ADDENDUM #1

Hasty Community Center Renovations – Bid #2017-008

City of Auburn, Maine

28 November 2016

Sheet Number:
A3.2

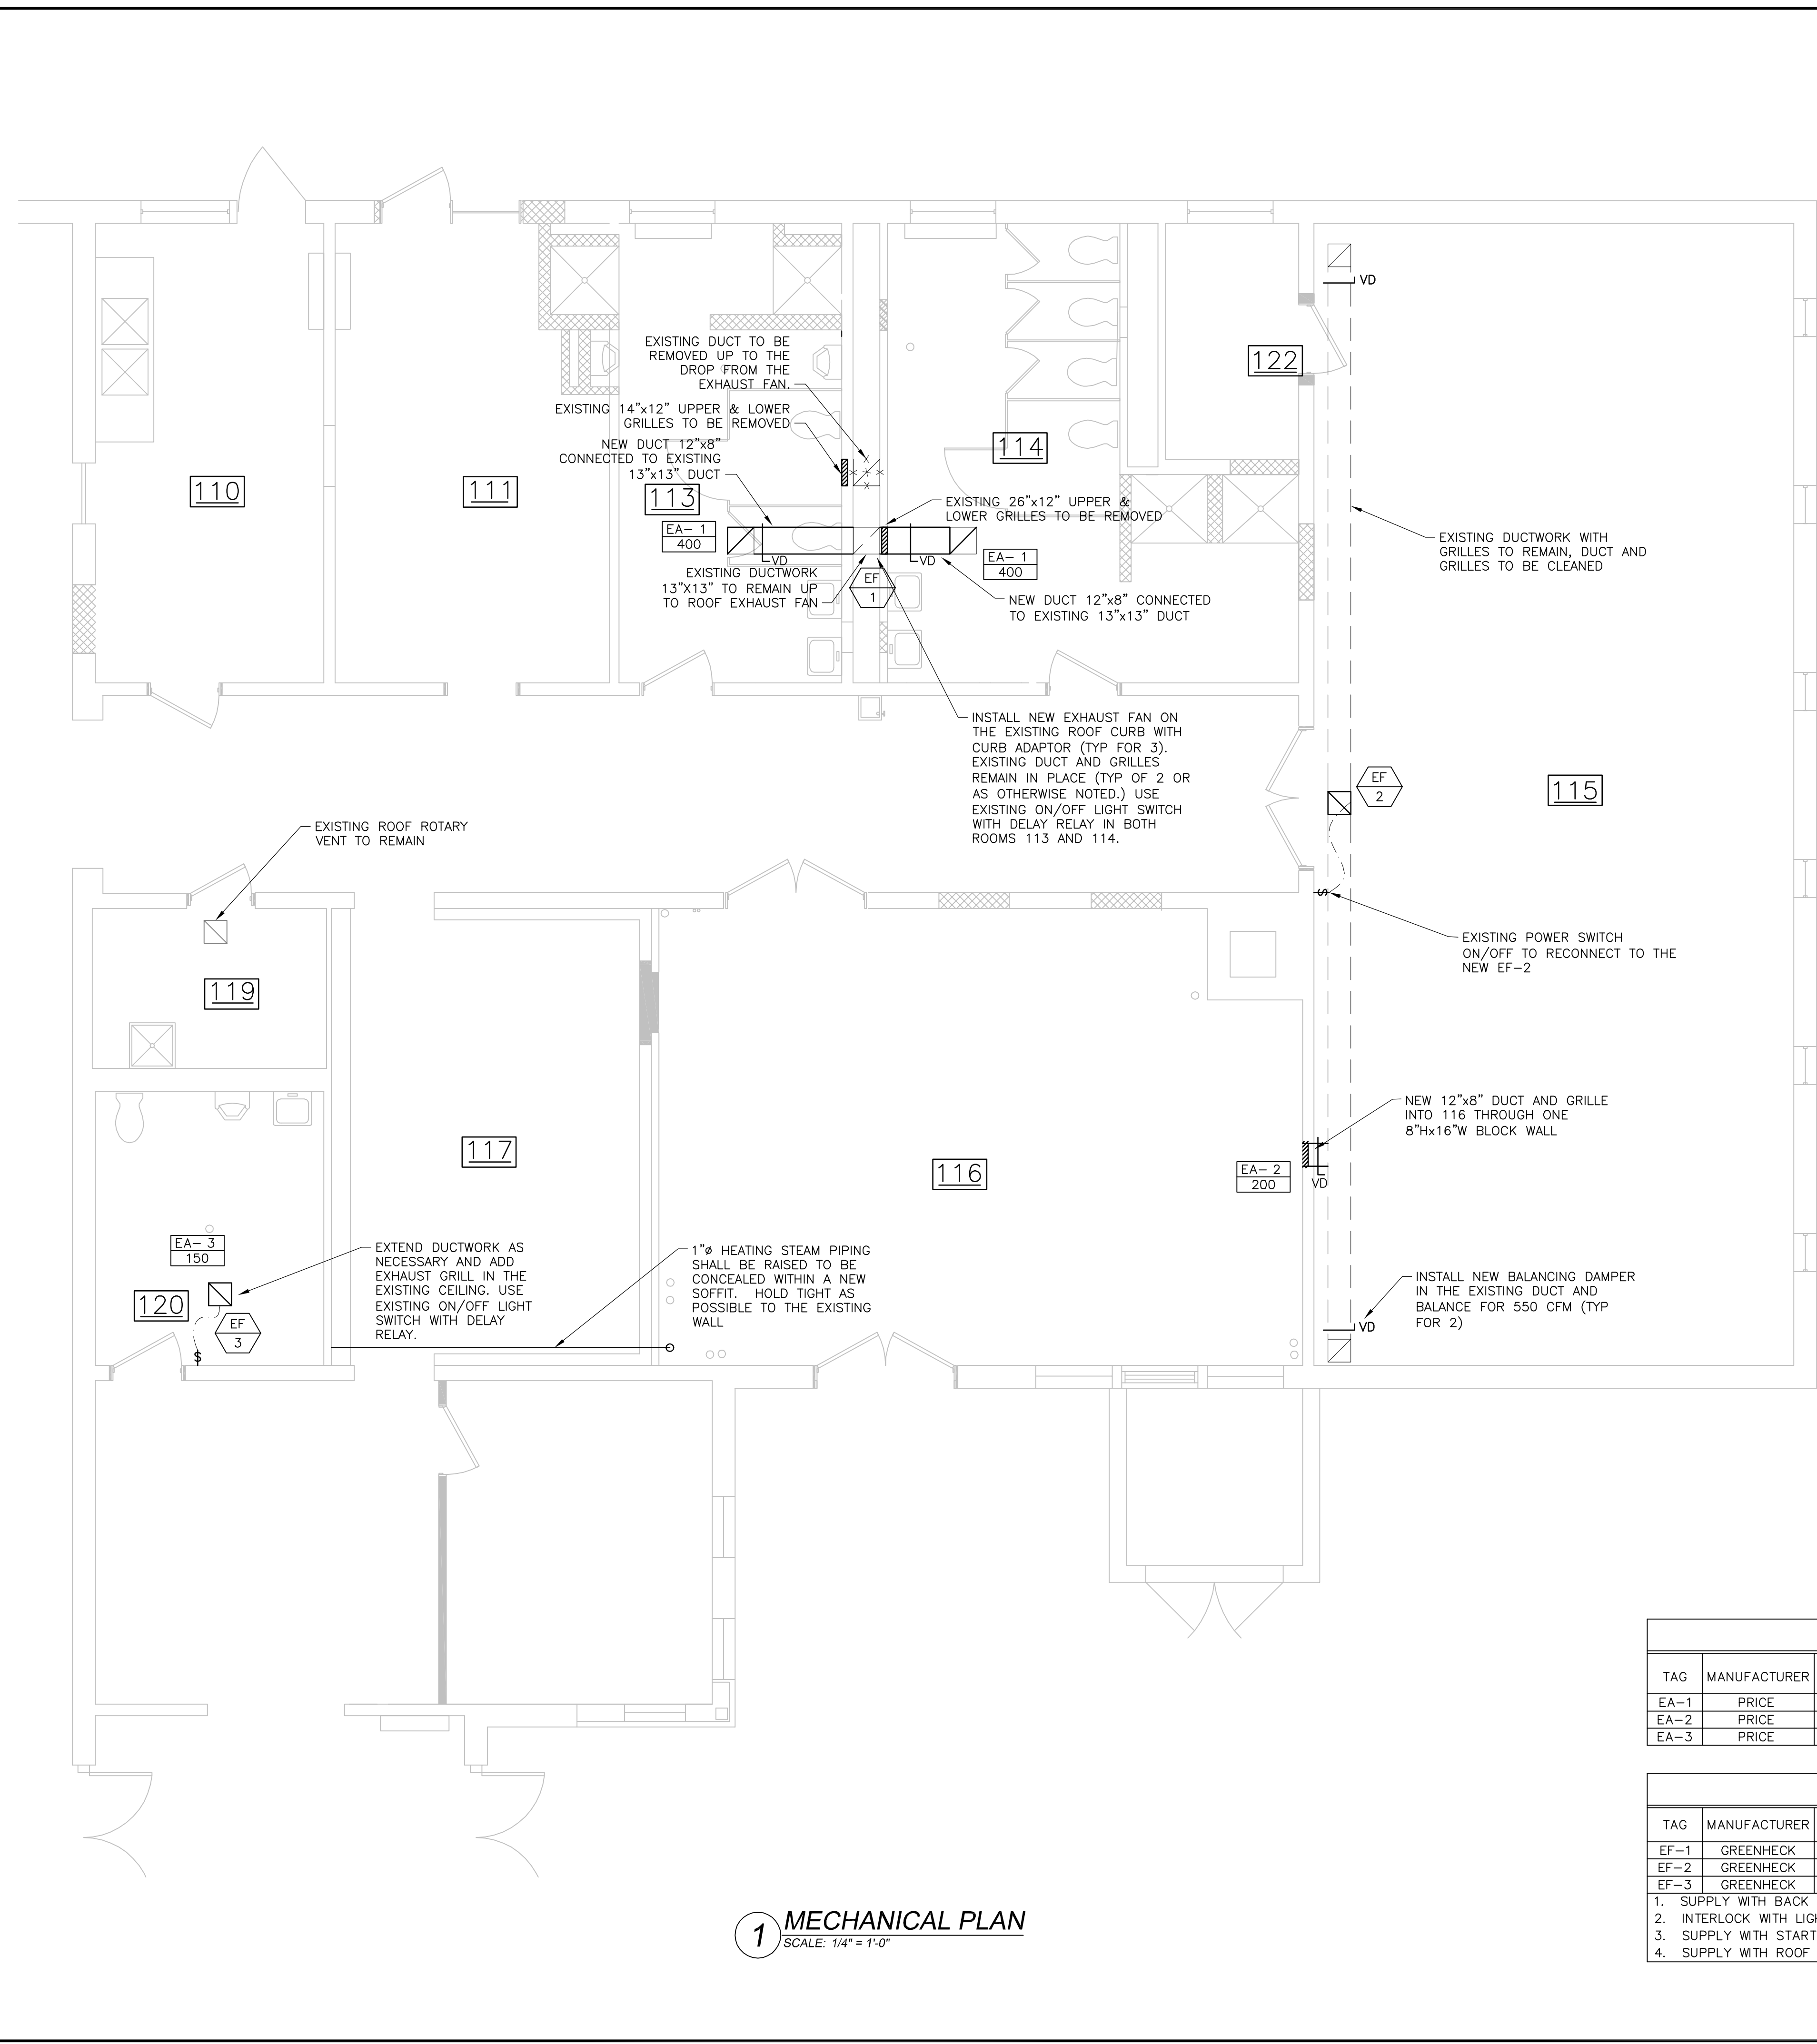
4. **Drawing A3.2: DELETE** drawing A3.2 in its entirety. **REPLACE** with the attached revised drawing A3.2. Revisions include modifications to the restroom elevation to remove the towel bars and replace with robe hooks.

01	PLUMBING CHASE	11/23/16
No.	Revision/Issue	Date
Design by:	MI	Checked by: MAD
Drawn by:	RR	Approved by: BMB
Project:	NO. 964	Date: SEPTEMBER 28, 2016
Sheet Number:	E-1

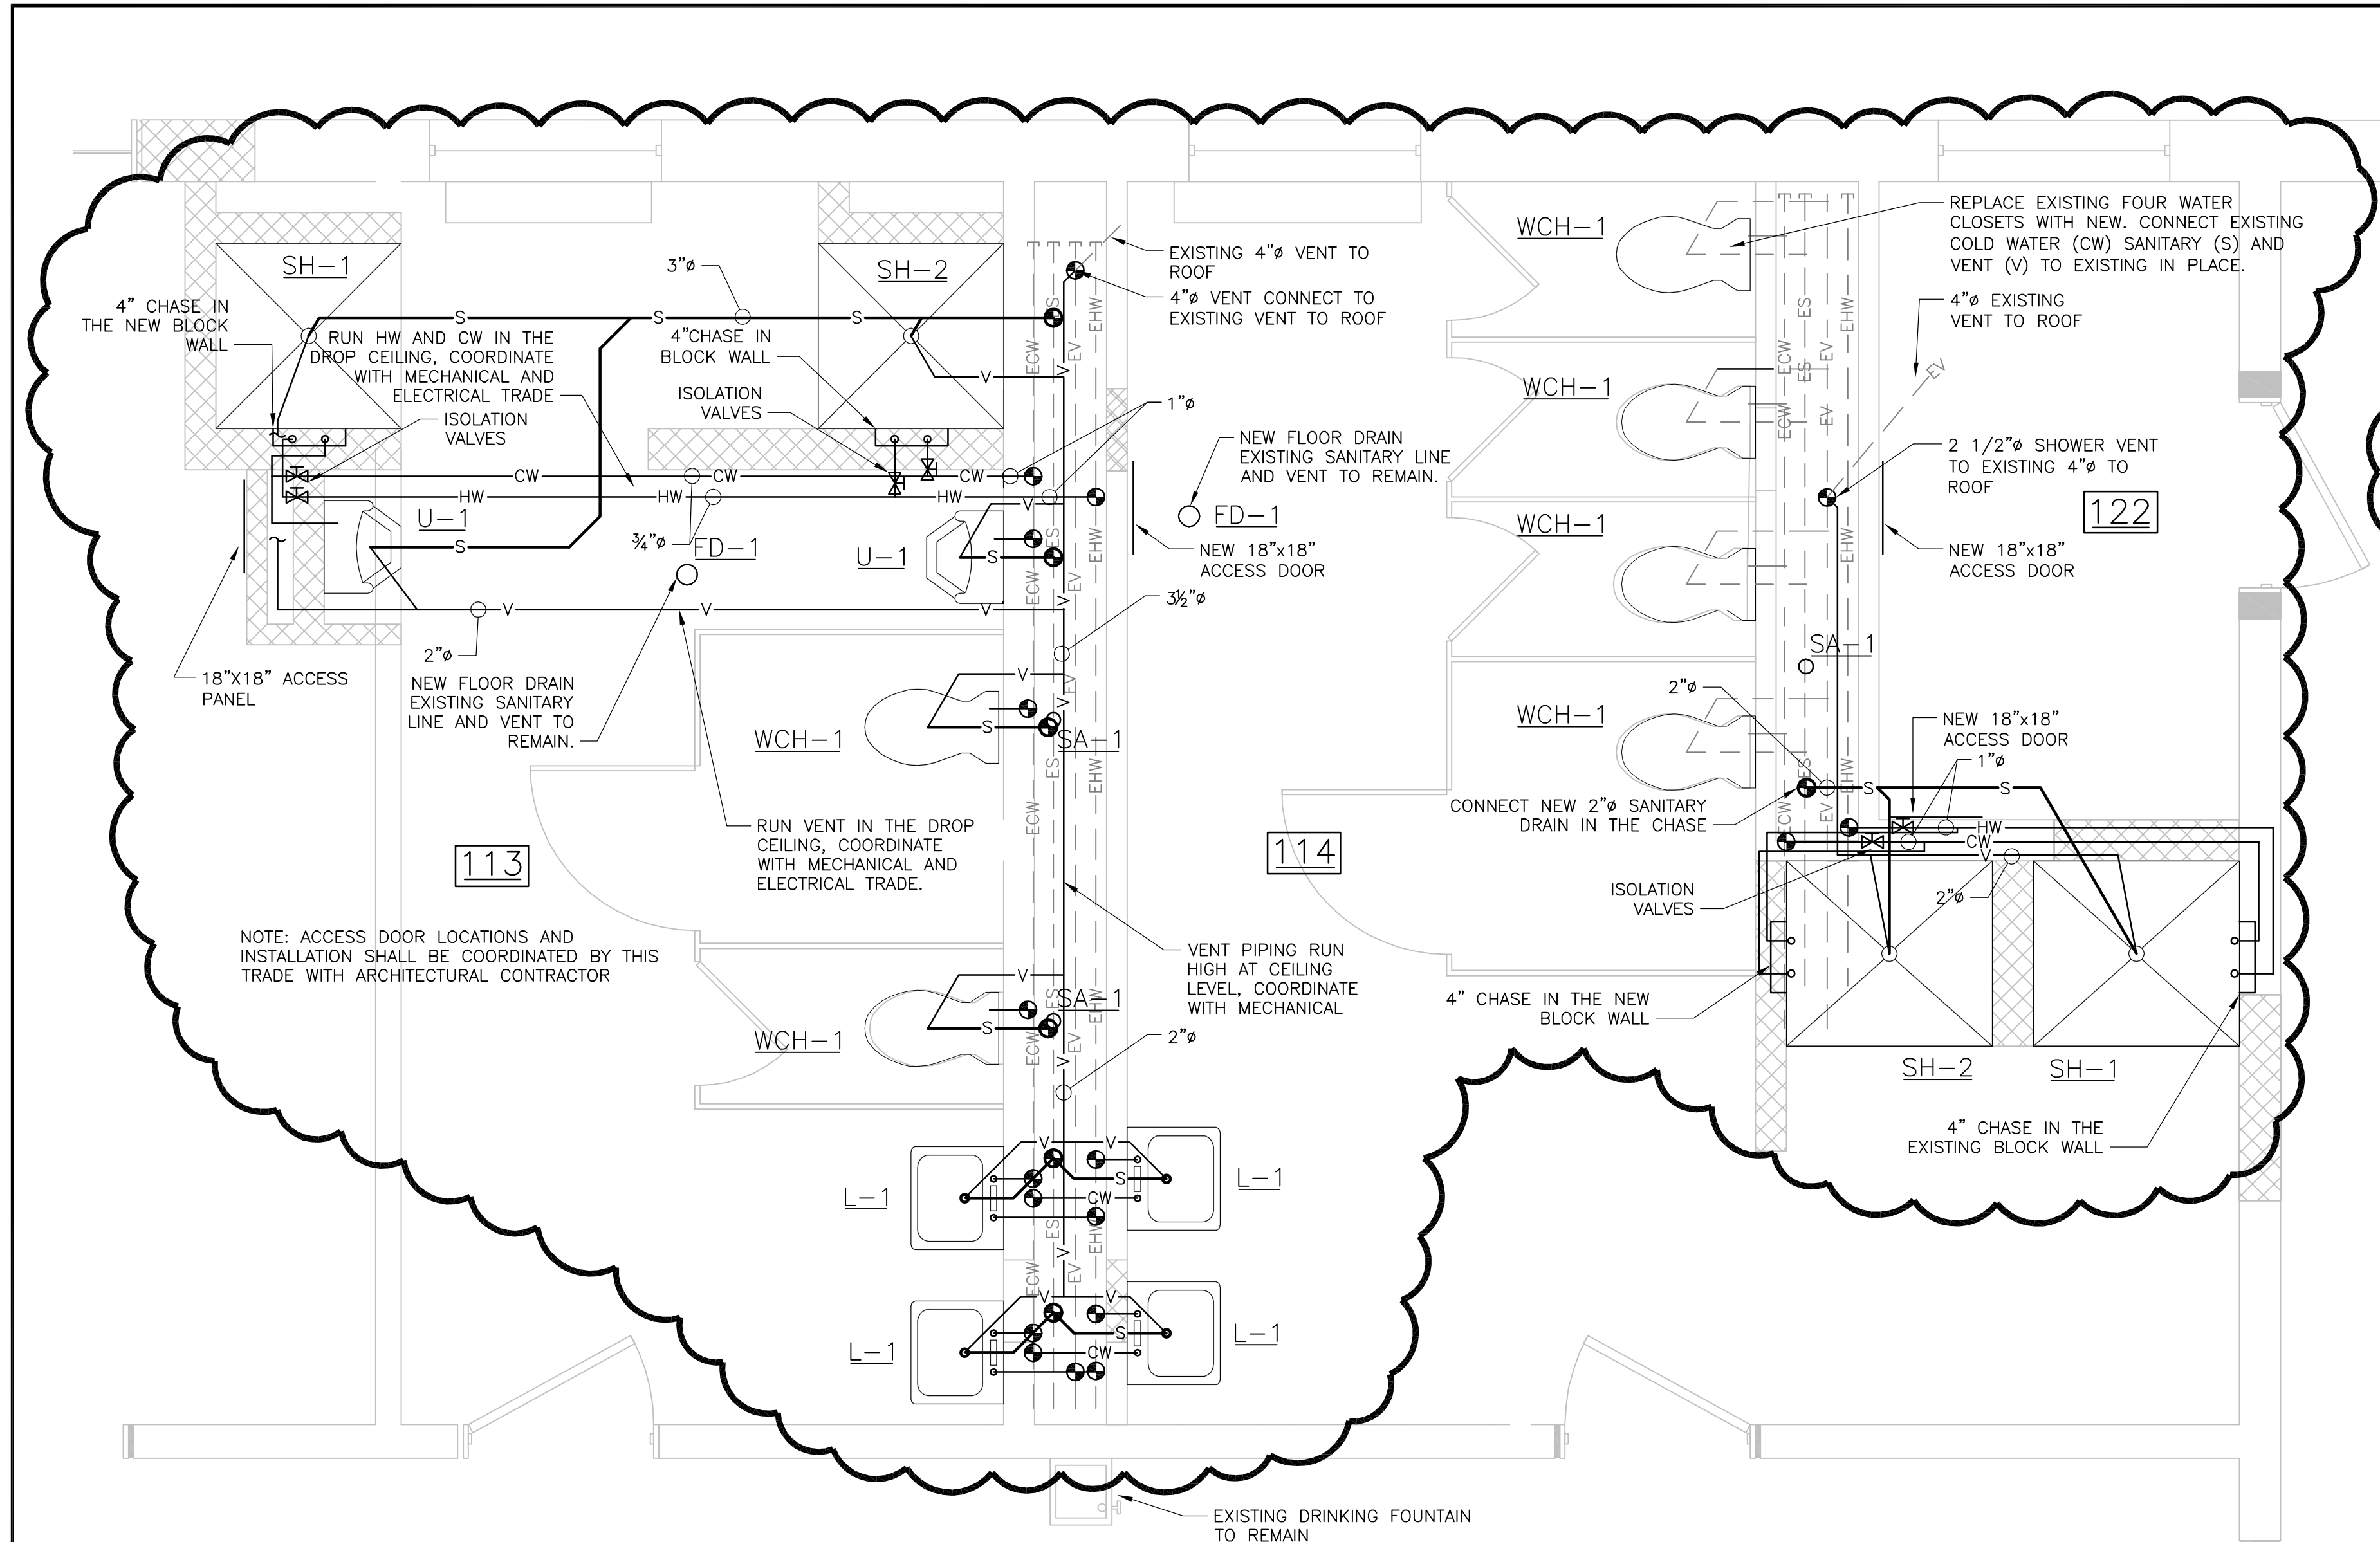
6. **Drawing E-1: DELETE** drawing E-1 in its entirety. **REPLACE** with the attached revised drawing E-1. Revisions include modifications to the restroom walls, toilet partitions and plumbing fixture layouts to accommodate a less complicated plumbing installation.

Sheet Number:
P-2

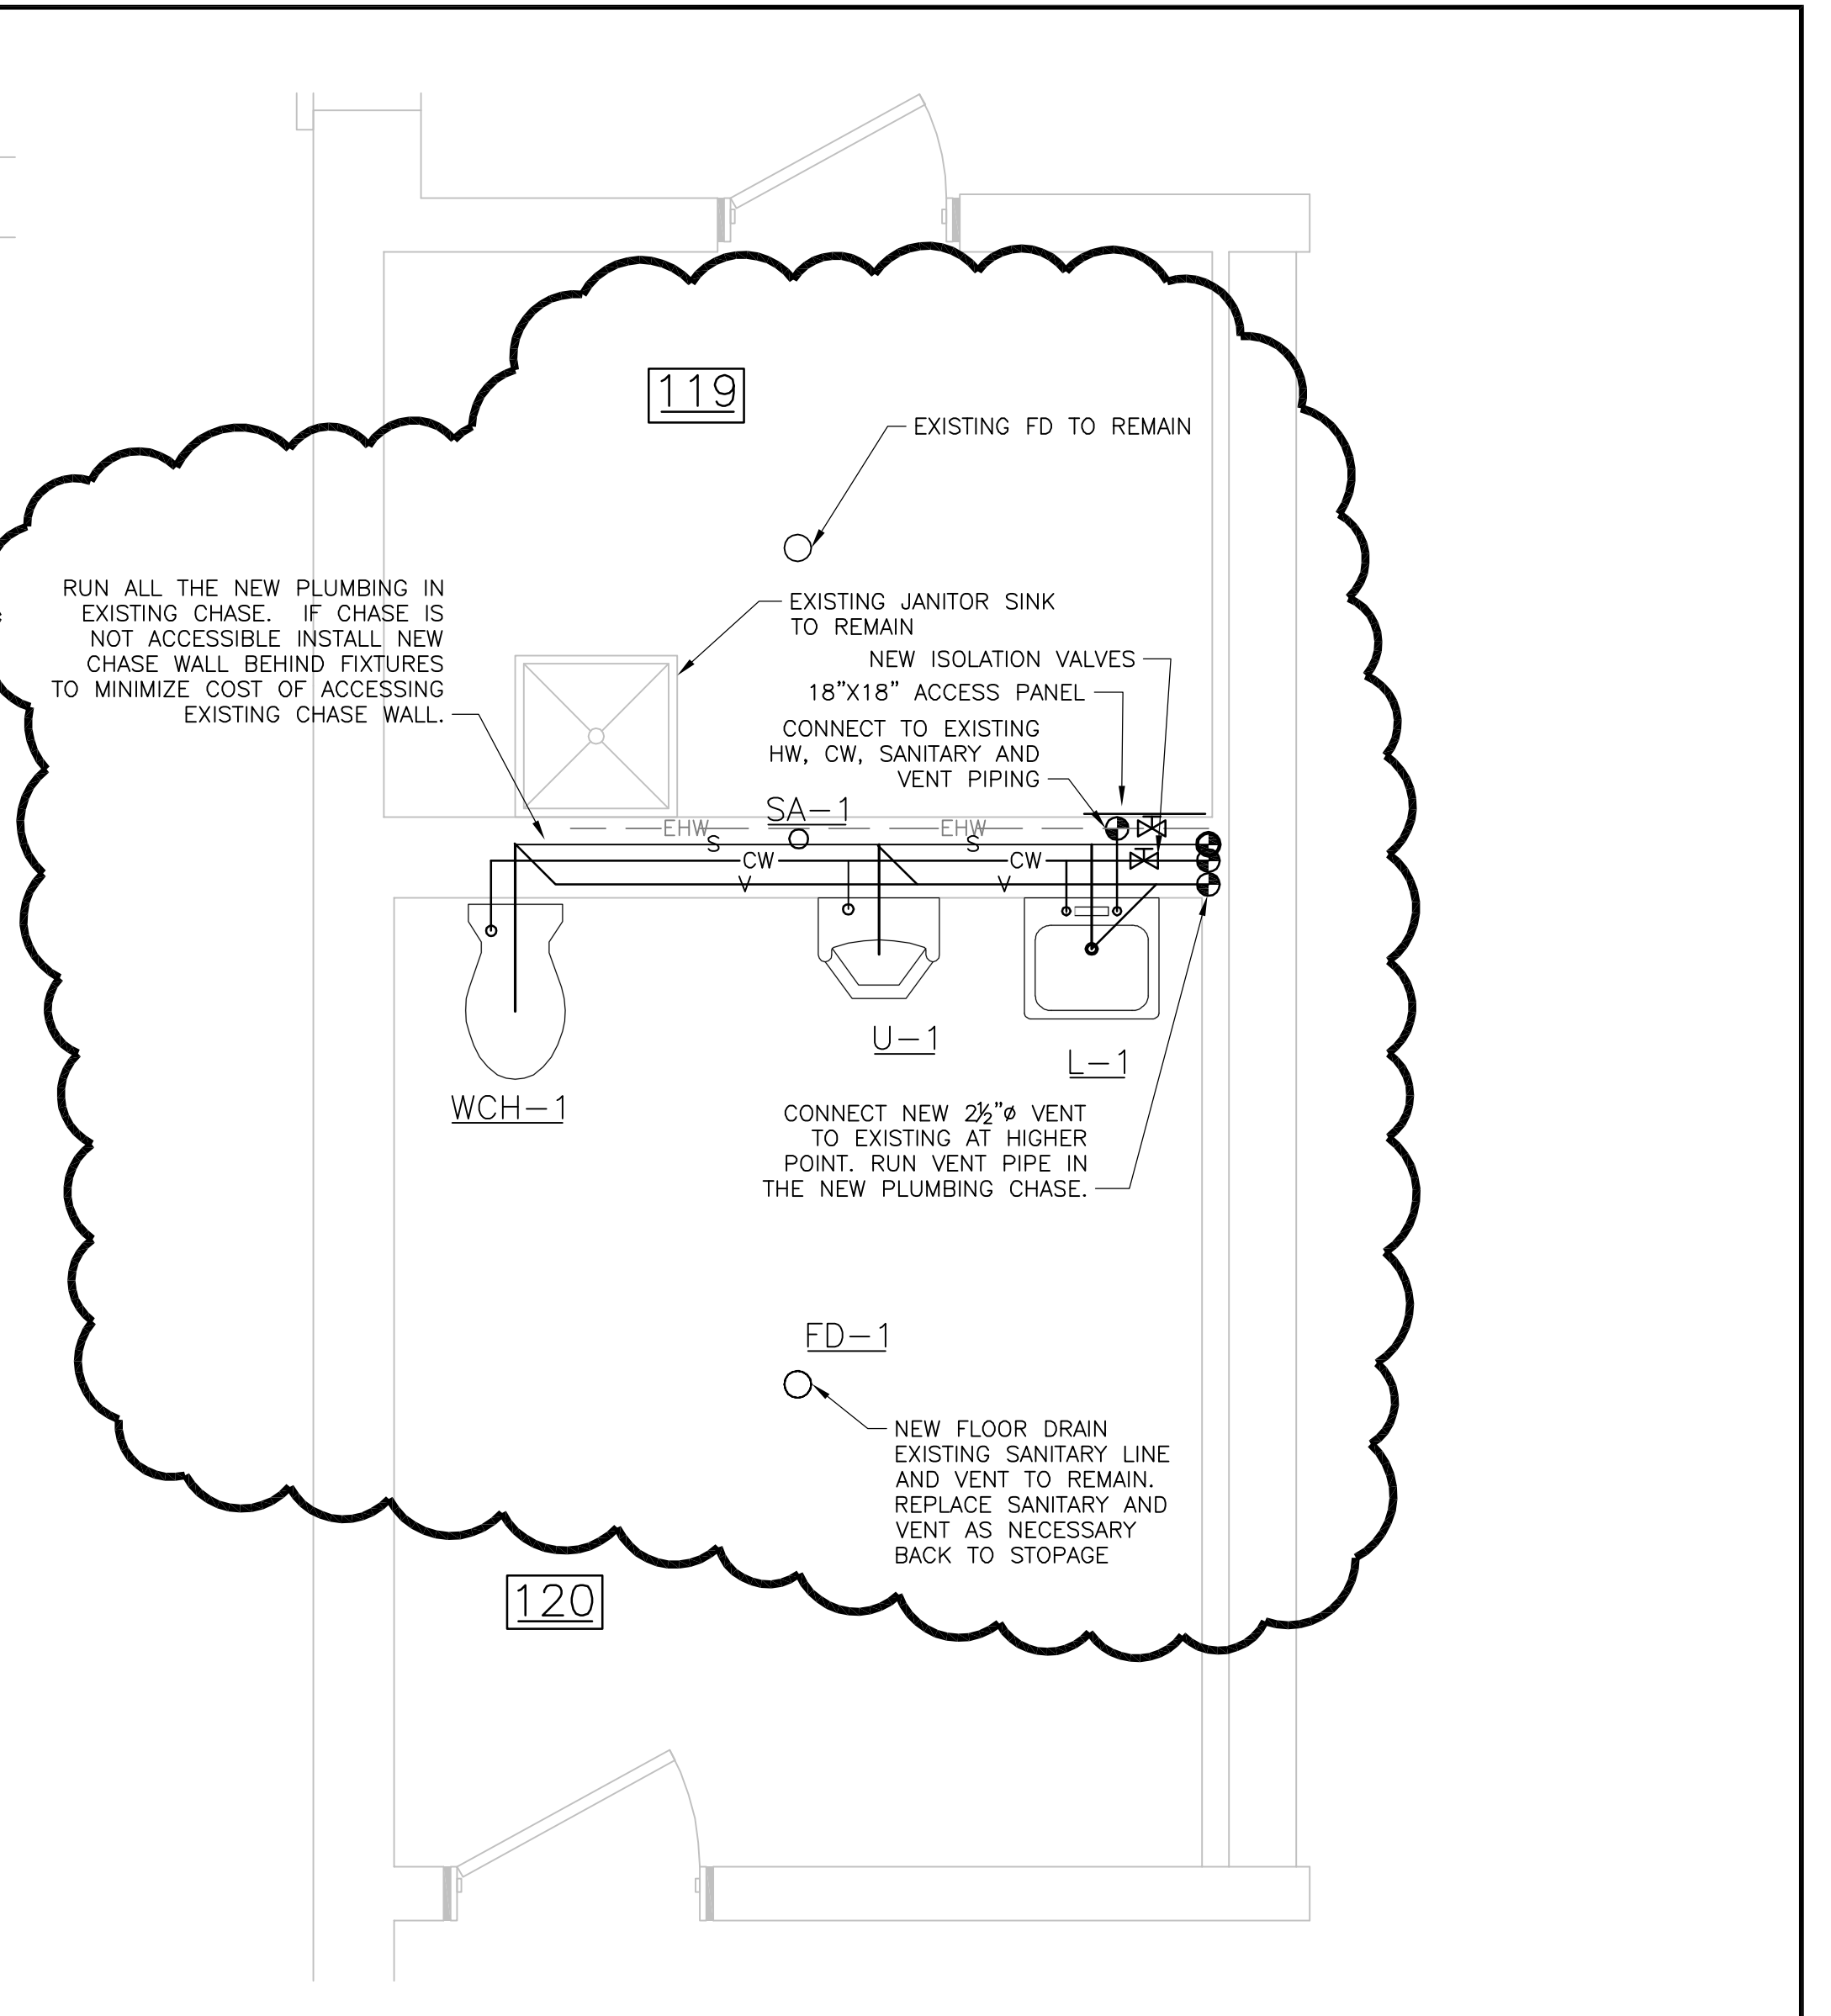
7. **Drawing P-2: DELETE** drawing P-2 in its entirety. **REPLACE** with the attached revised drawing P-2. Revisions include modifications to the restroom walls, toilet partitions and plumbing fixture layouts to accommodate a less complicated plumbing installation.
